**ADDENDUM NO. 1
FEBRUARY 26TH, 2026**

PROJECT: ANSON ISD
ELEMENTARY & HIGH SCHOOL CLASSROOM ADDITION

BID DATE: MARCH 5TH, 2026

NO.	REVISION	DATE
1	ADDENDUM #1	02/26/2026
PROJECT #	25320	
SCALE	1/8" = 1'-0"	
SHEET		
2E3.1

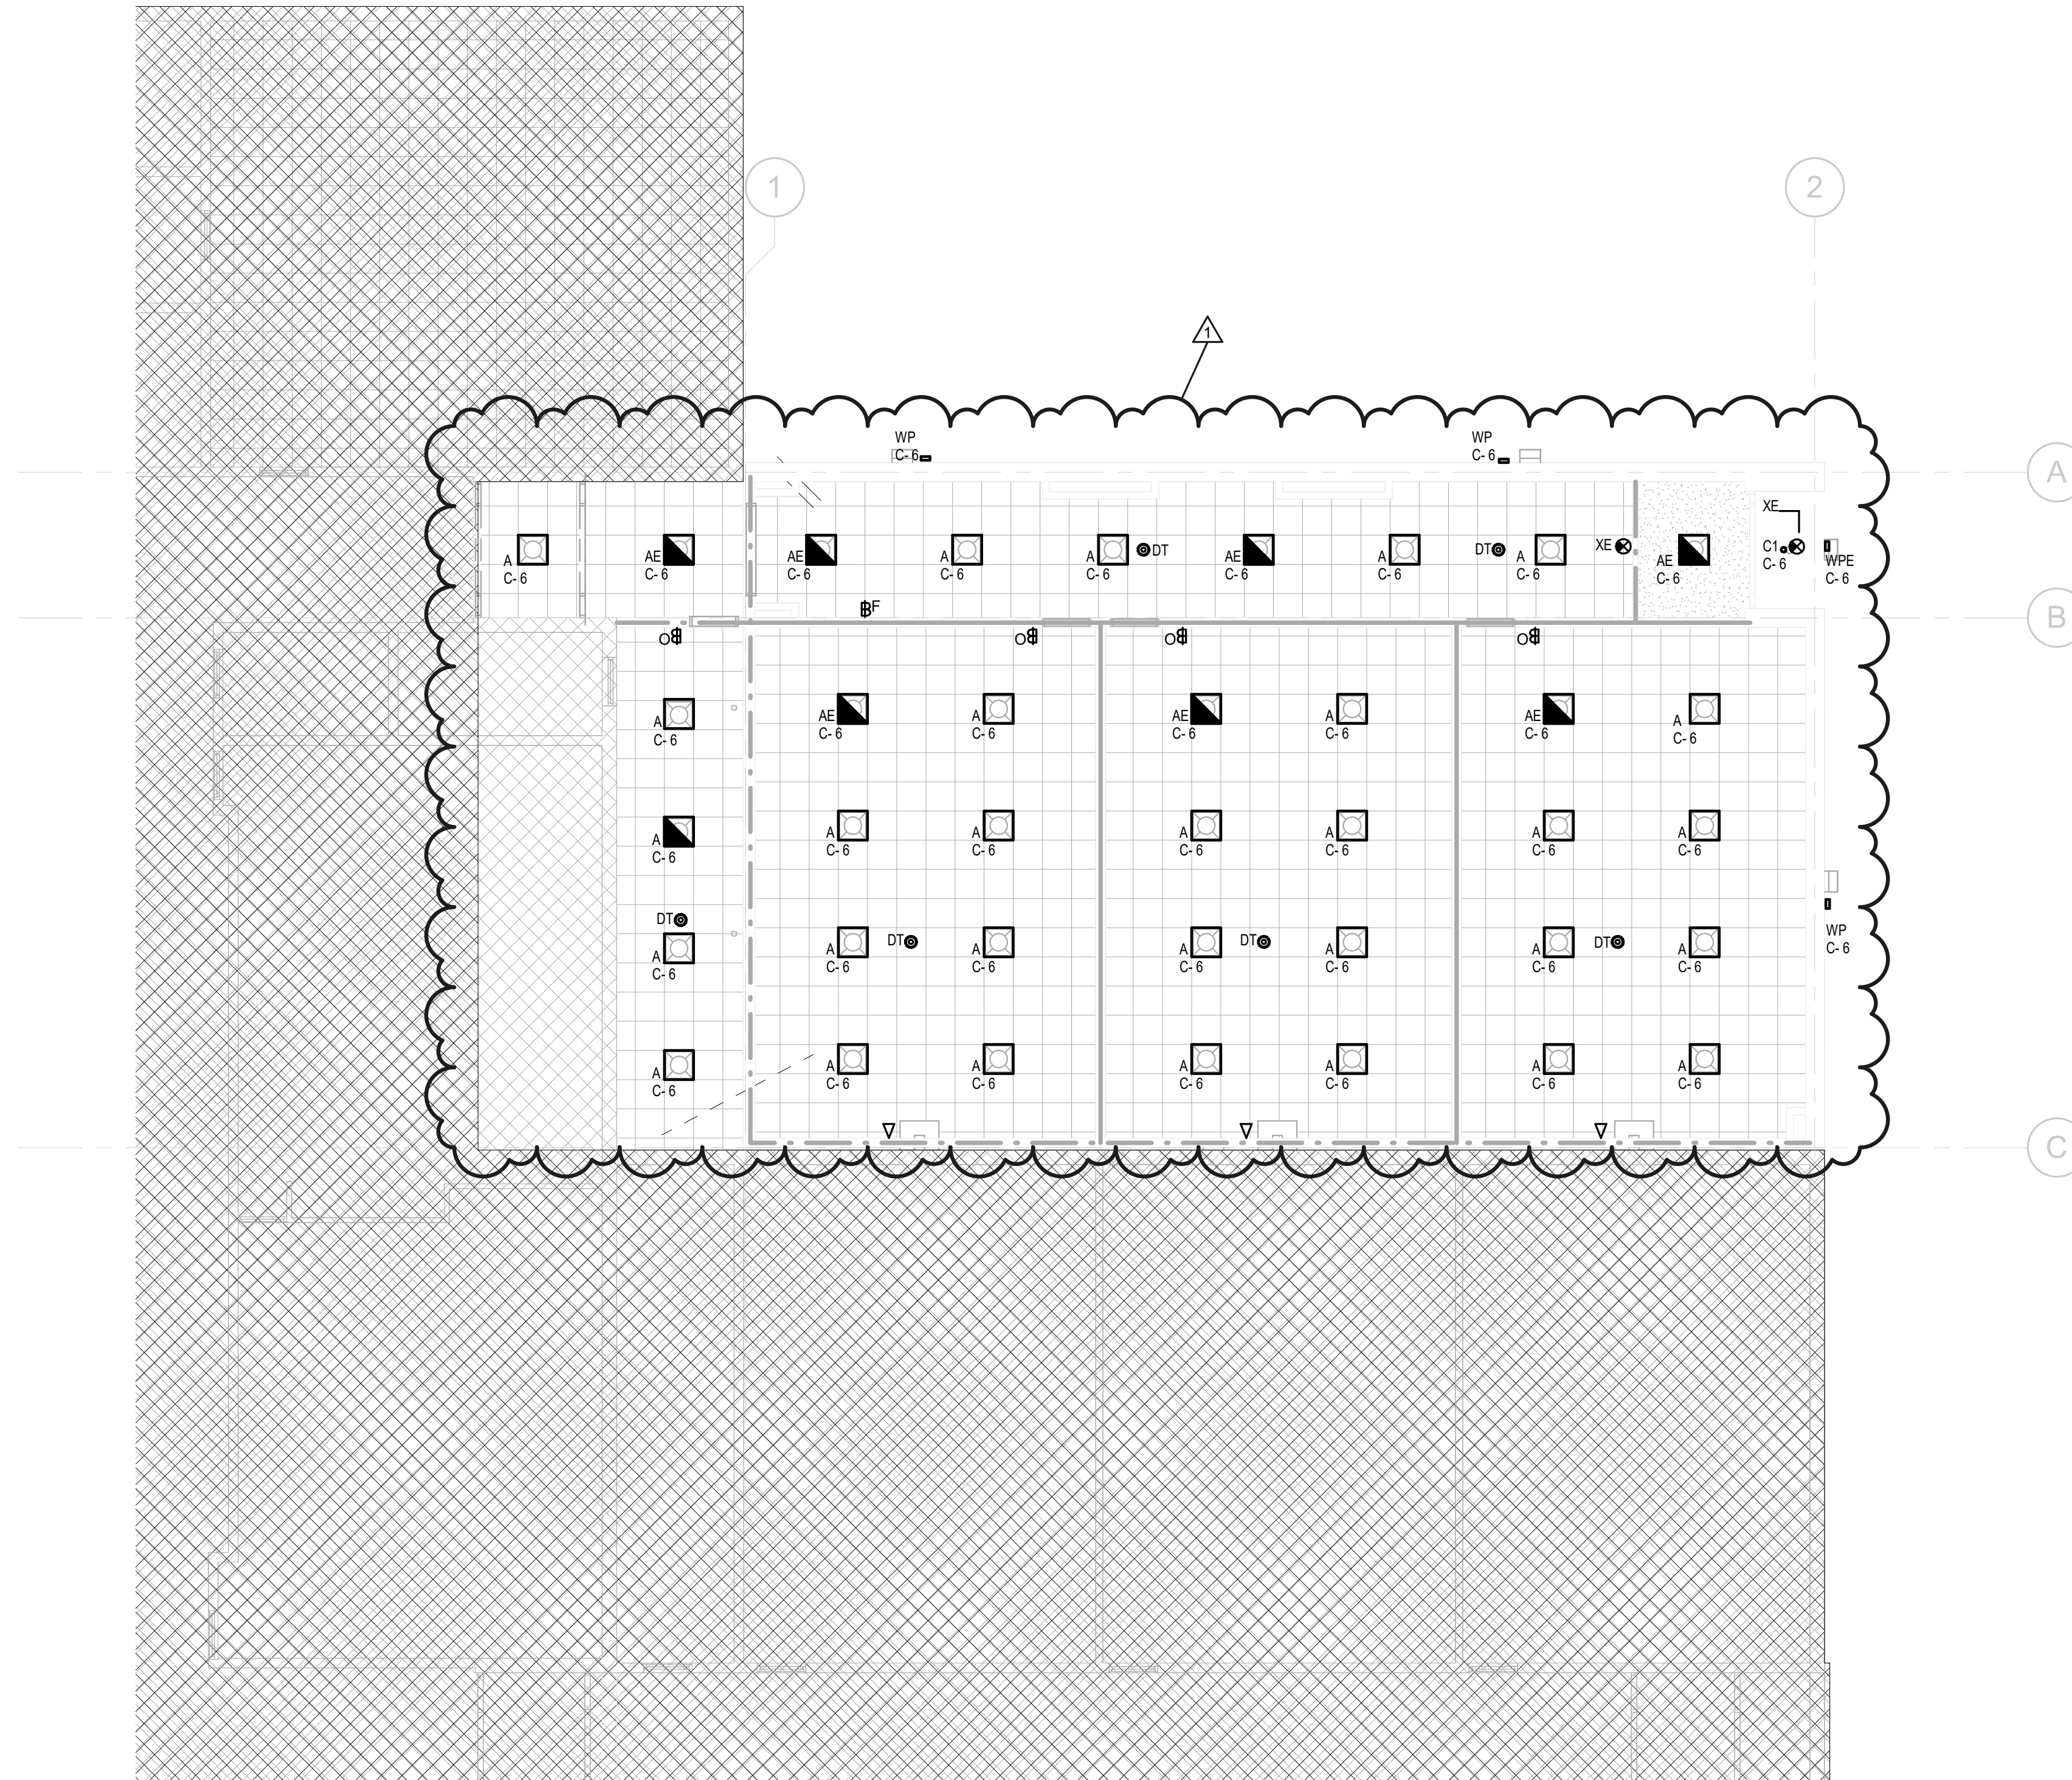
- Item #D16** **Sheet 2E3.0** – REPLACE sheet with attached sheet 2E3.0 dated 02-26-2026. UPDATED lighting fixture schedule.
- Item #D17** **Sheet 2E3.1** – REPLACE sheet with attached sheet 2E3.1 dated 02-26-2026. UPDATED reflected ceiling plan with updated lighting layout in Vest. 106 & Corridor 100.
